RE: **Lot 10 Block 4 Unit 18, S.A.D. 228**
Volcano Cliffs Subdivision
6611 Cuervo Pl. NW
Grading and Drainage Plan
Engineers Stamp Date; 12-13-2021 (D10D003J10)
Pad Certification Date; 1/27/2022

Based upon the information provided in your submittal received 1/31/2022, this plan cannot be approved for pad certification until the following comments are addressed.

DRAINAGE AND TRANSPORTATION INFORMATION SHEET (REV 6/2018)

6611 CUERVO PL NW ALBUQUERQUE NM 87120
CITY OF ALBUQUERQUE, BERNALILLO COUNTY NEW MEXICO

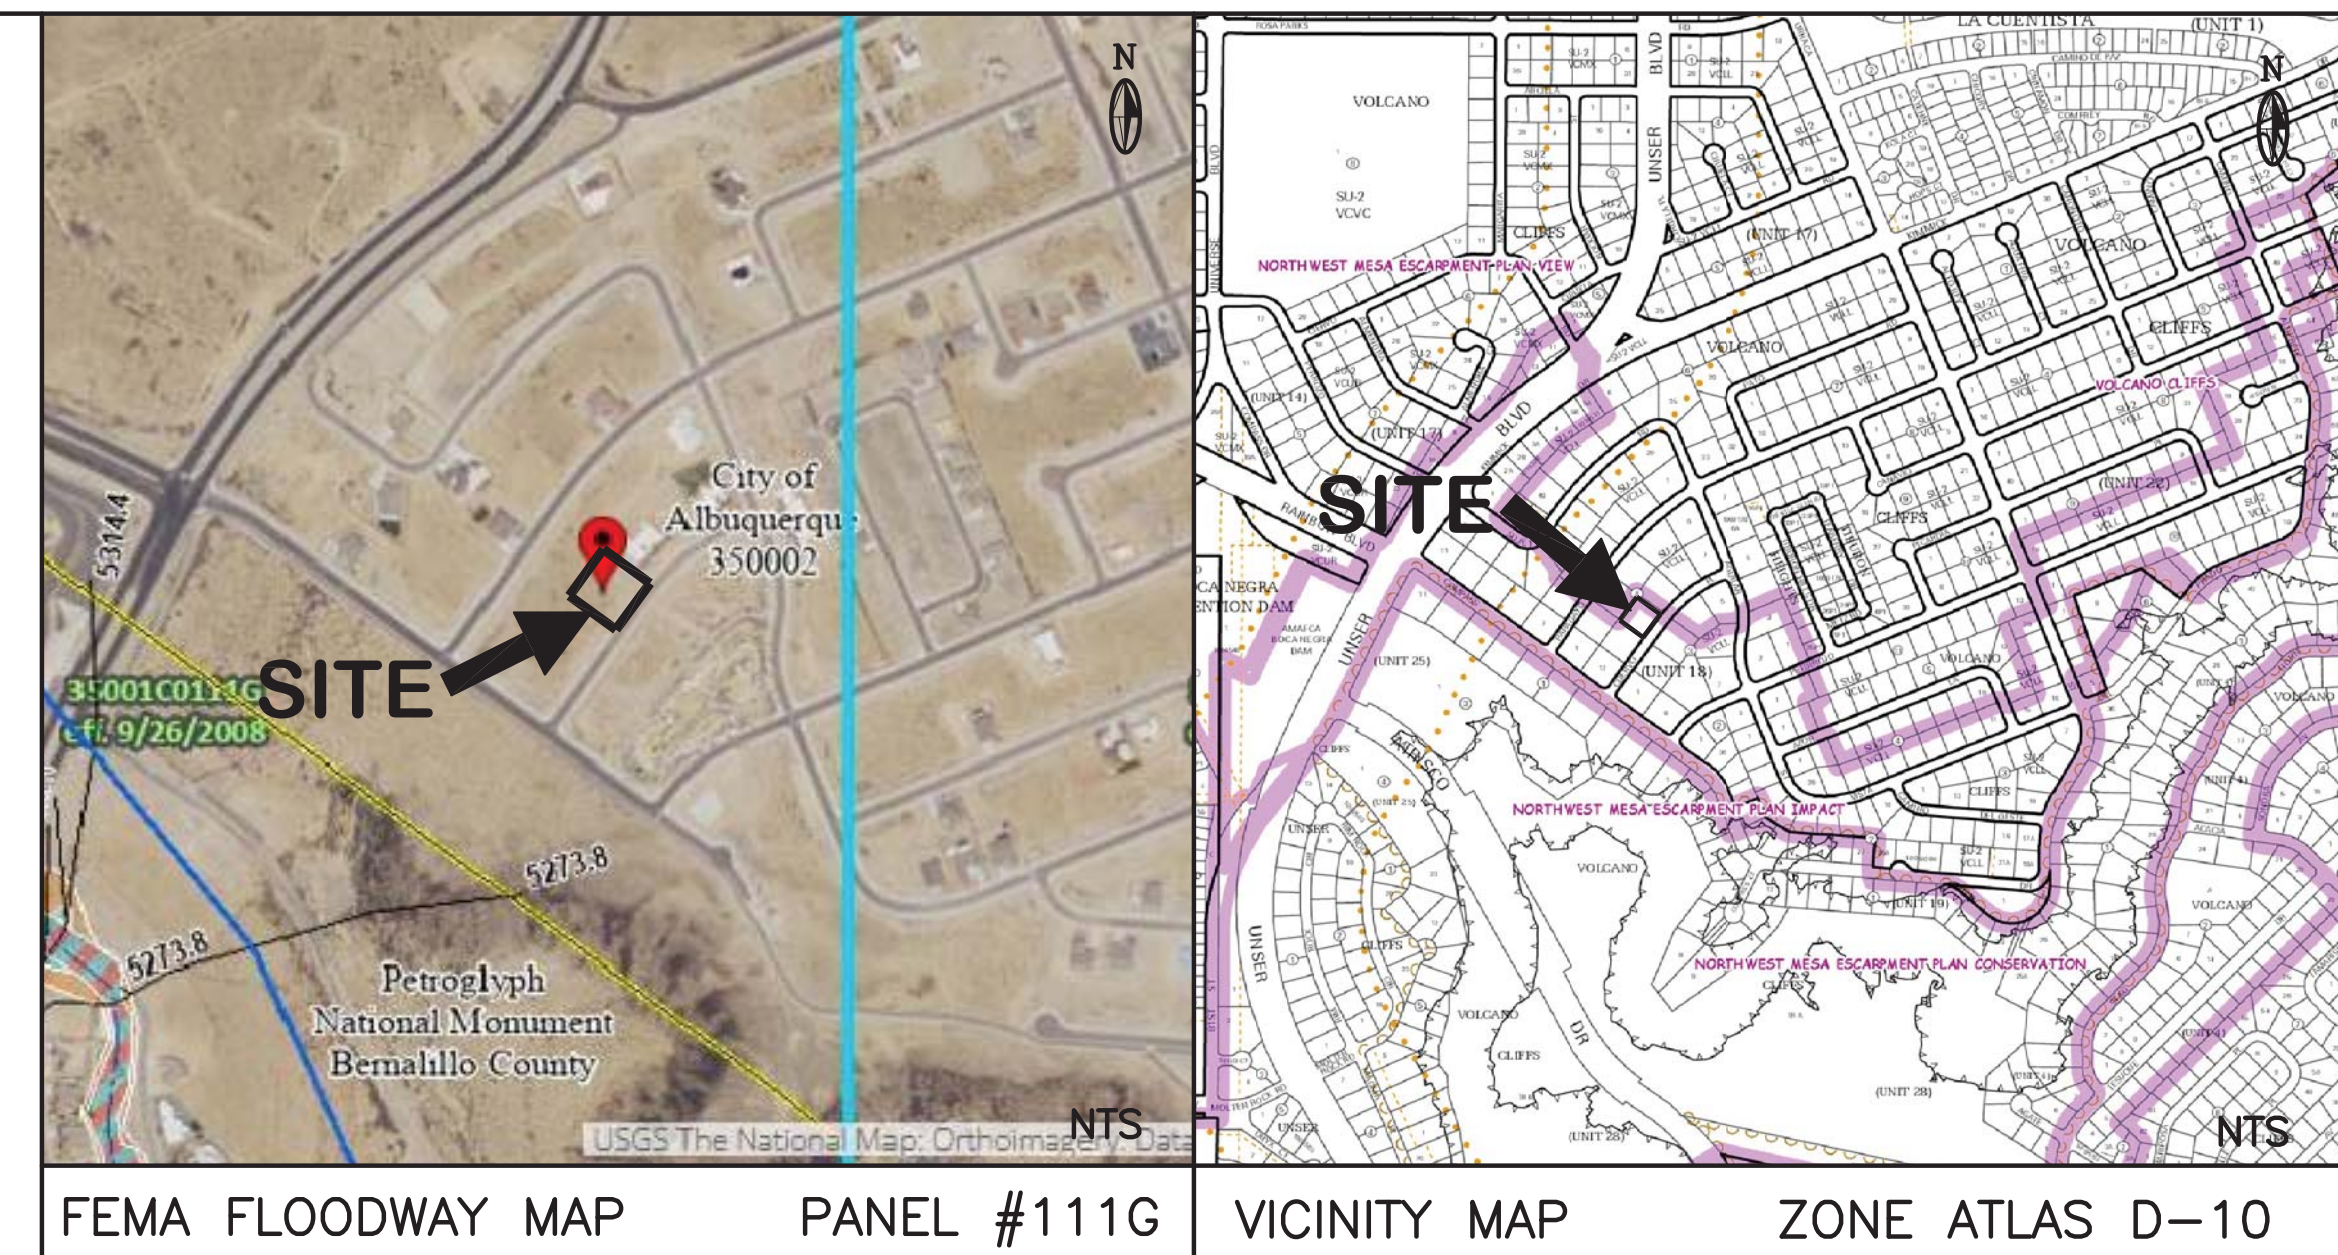
- Remove all dirt and debris from the public right of way.
